SCHEDULE OF DESIGN AMENDMENTS

STATUS
SECTION 4.55

PROJECT
HOMEBUSH APARTMENTS

DRAWING NO.
DA000

1 BUILDING A - NORTH ELEVATION
scale - 1:200 @ A1

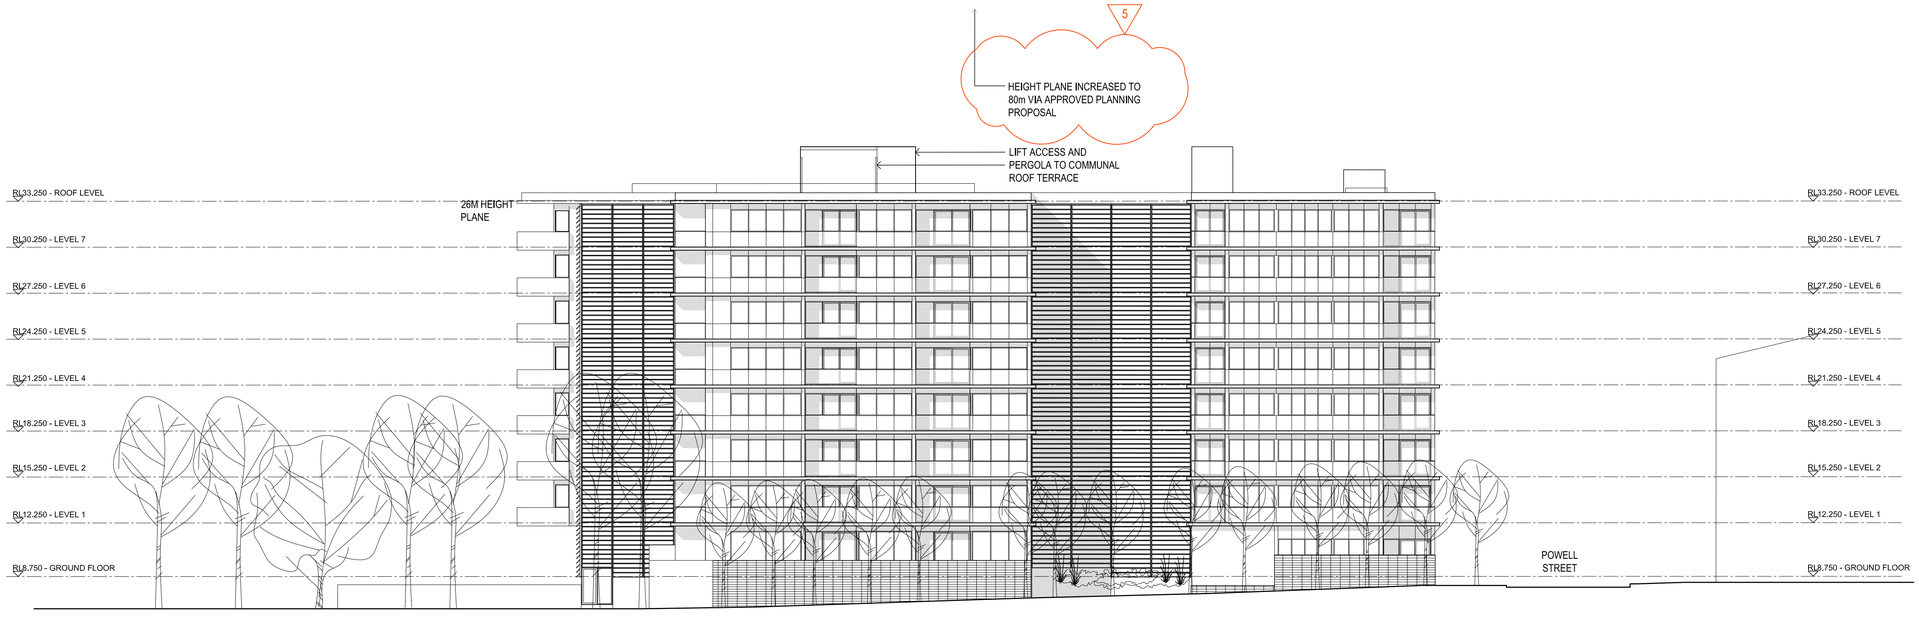
1. FACADE AMENDED TO BUILDING B AMENDED TO ALLOW FOR LOW MAINTENANCE & FIRE RATED BRICKWORK
2. PARAPET ADDED TO LEVEL 7 AS PART OF NEW BRICKWORK DESIGN AND PROVIDE FALL ARREST FOR ROOF MAINTENANCE
3. 3rd LIFT ADDED TO BUILDING B
4. GROUND FLOOR COLUMNS AMENDED TO ACCOMMODATE NEW FACADE DESIGN
5. HEIGHT PLANE INCREASED FROM 25m TO 80m
6. FLOOR TO FLOOR OF RESIDENTIAL LEVELS INCREASED 50mm PER LEVEL FOR BUILDABILITY GIVEN NEW LEGISLATIVE REQUIREMENT FOR SPRINKLERS TO BUILDINGS ABOVE 4 STOREYS

2 WEST ELEVATION
scale - 1:200 @ A1

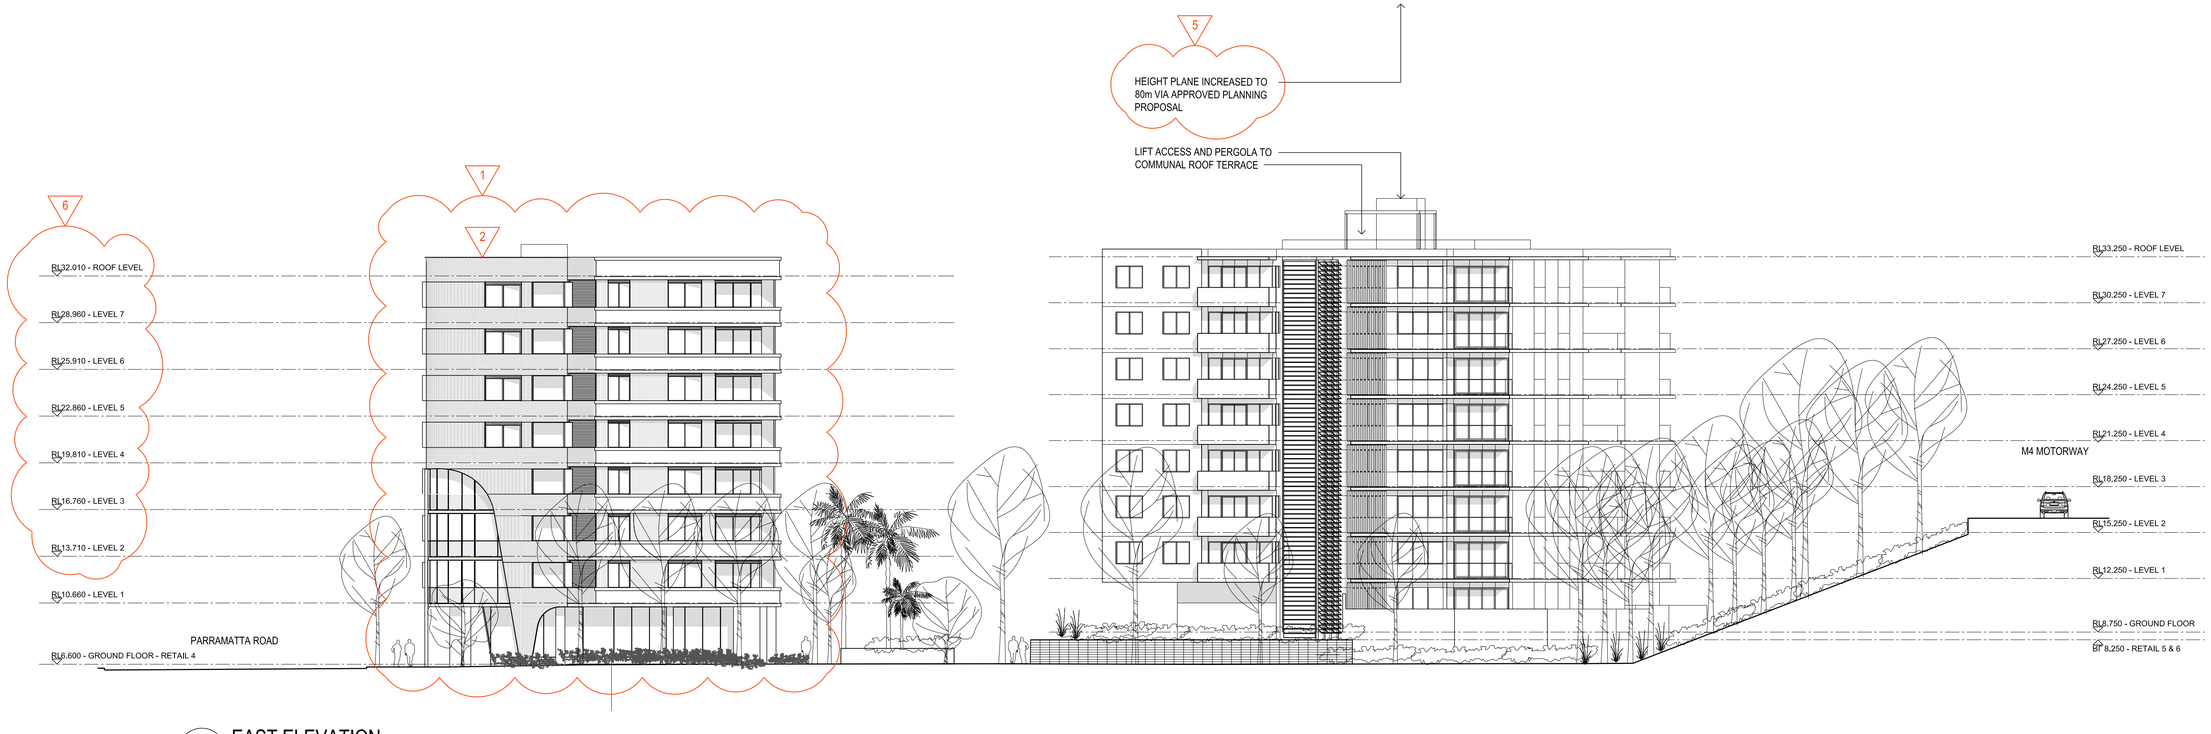
1. FACADE AMENDED TO BUILDING B AMENDED TO ALLOW FOR LOW MAINTENANCE & FIRE RATED BRICKWORK
2. PARAPET ADDED TO LEVEL 7 AS PART OF NEW BRICKWORK DESIGN AND PROVIDE FALL ARREST FOR ROOF MAINTENANCE
3. 3rd LIFT ADDED TO BUILDING B
4. GROUND FLOOR COLUMNS AMENDED TO ACCOMMODATE NEW FACADE DESIGN
5. HEIGHT PLANE INCREASED FROM 25m TO 80m
6. FLOOR TO FLOOR OF RESIDENTIAL LEVELS INCREASED 50mm PER LEVEL FOR BUILDABILITY GIVEN NEW LEGISLATIVE REQUIREMENT FOR SPRINKLERS TO BUILDINGS ABOVE 4 STOREYS

1 SECTION A
scale - 1:200 @ A1

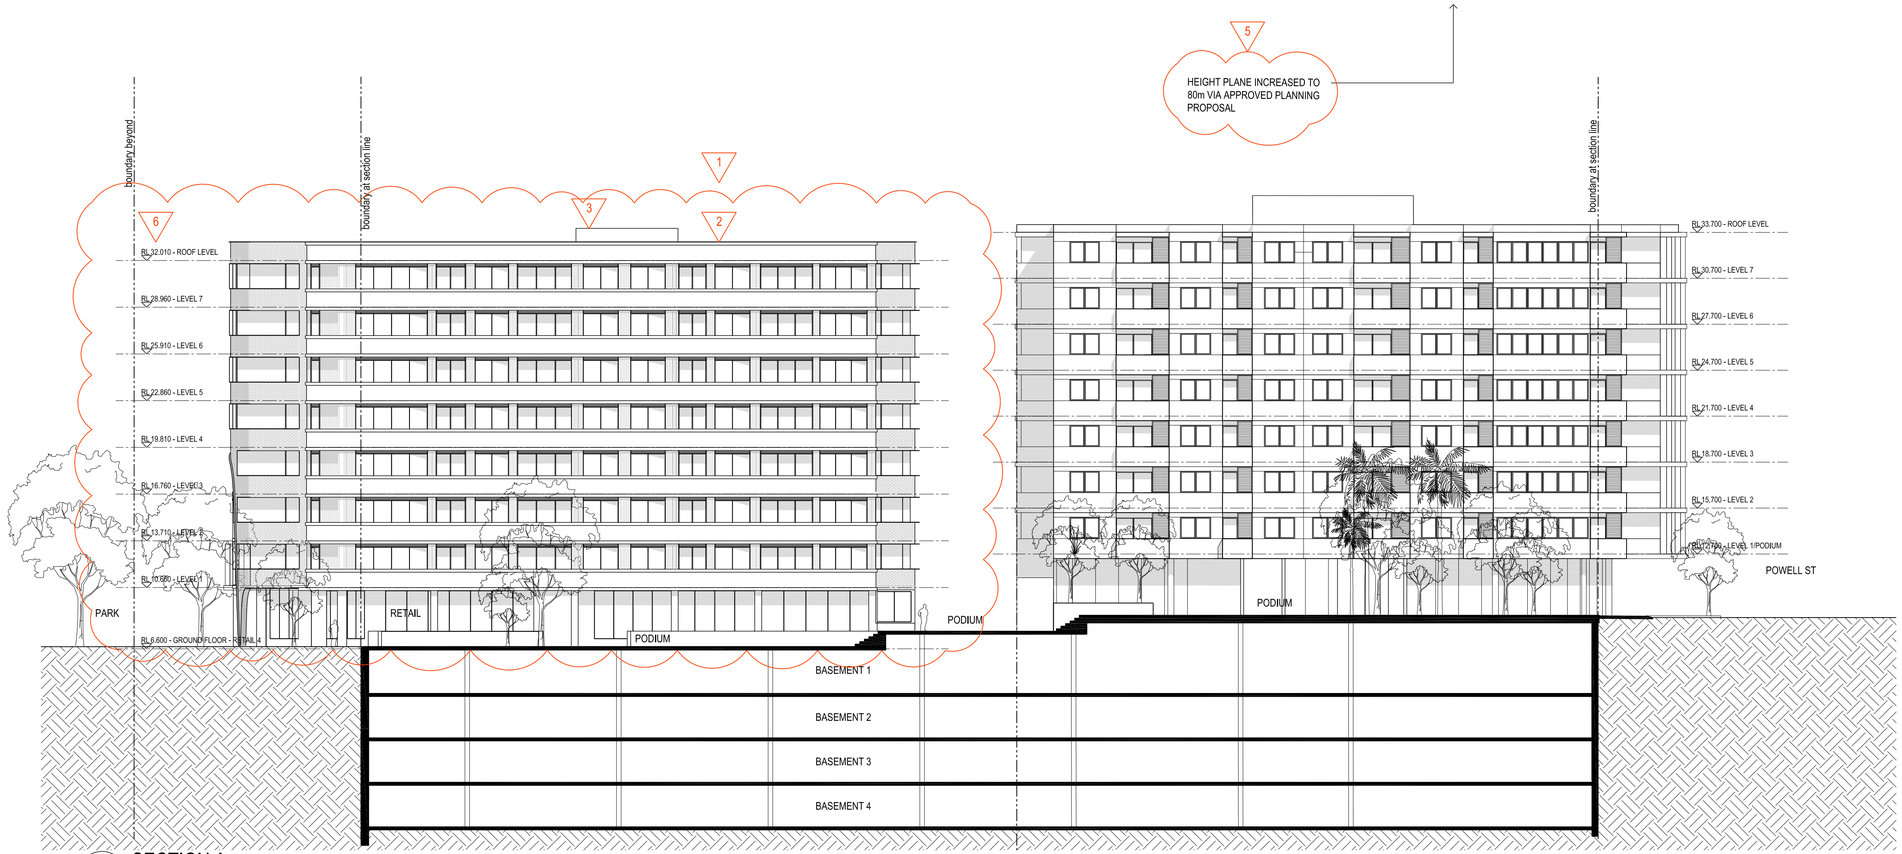
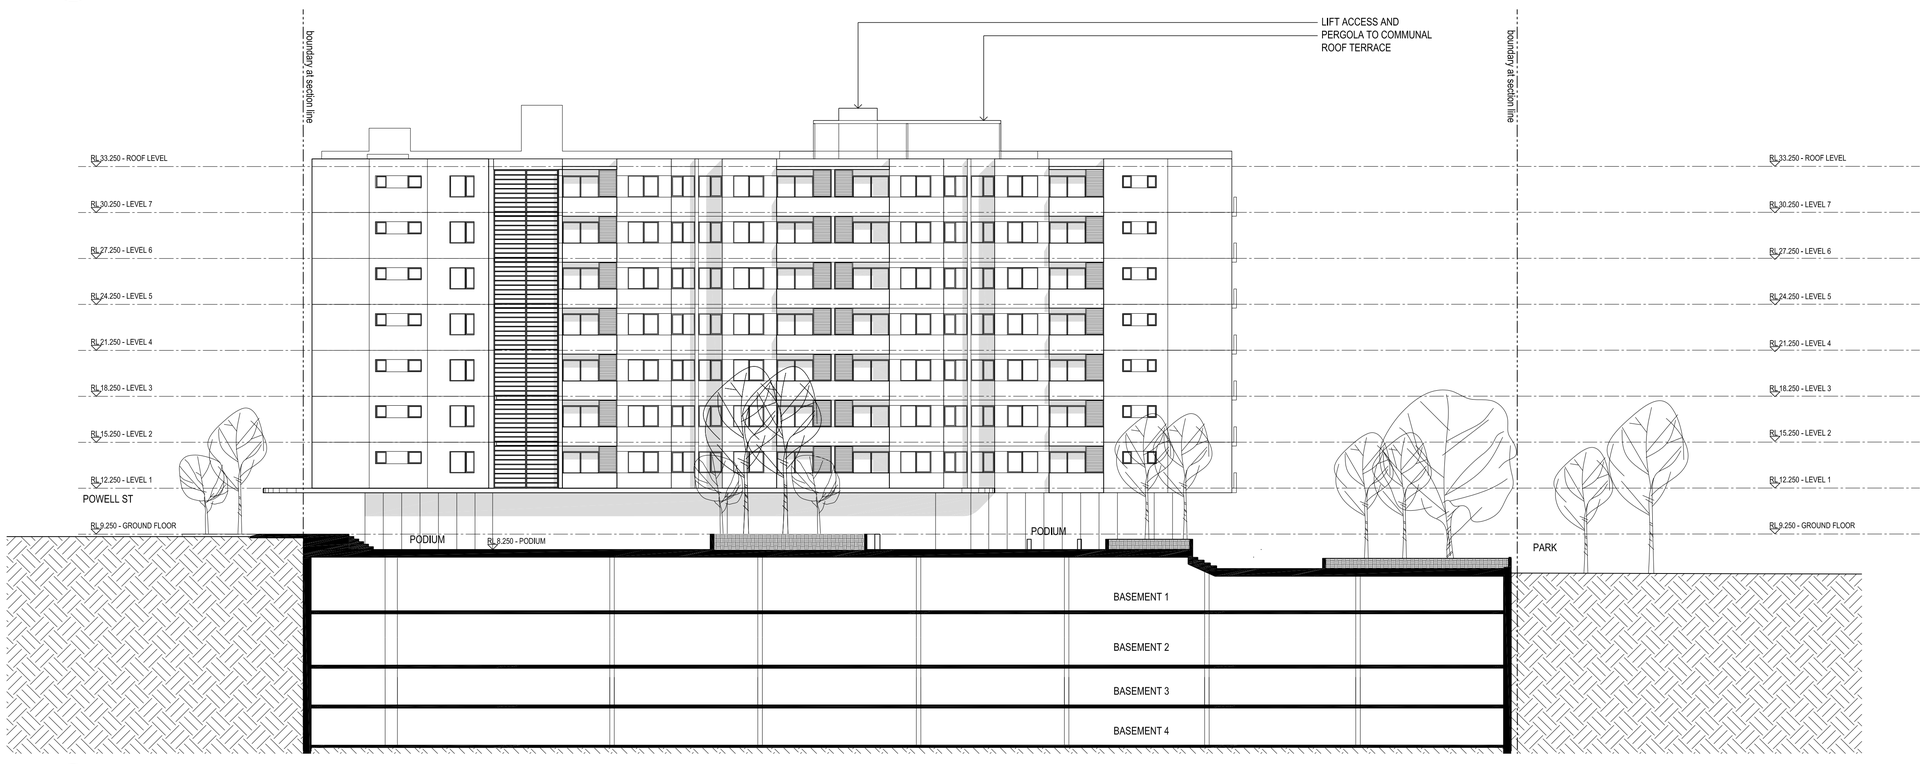
1. FACADE AMENDED TO BUILDING B AMENDED TO ALLOW FOR LOW MAINTENANCE & FIRE RATED BRICKWORK
2. PARAPET ADDED TO LEVEL 7 AS PART OF NEW BRICKWORK DESIGN AND PROVIDE FALL ARREST FOR ROOF MAINTENANCE
3. 3rd LIFT ADDED TO BUILDING B
4. GROUND FLOOR COLUMNS AMENDED TO ACCOMMODATE NEW FACADE DESIGN
5. HEIGHT PLANE INCREASED FROM 25m TO 80m
6. FLOOR TO FLOOR OF RESIDENTIAL LEVELS INCREASED 50mm PER LEVEL FOR BUILDABILITY GIVEN NEW LEGISLATIVE REQUIREMENT FOR SPRINKLERS TO BUILDINGS ABOVE 4 STOREYS
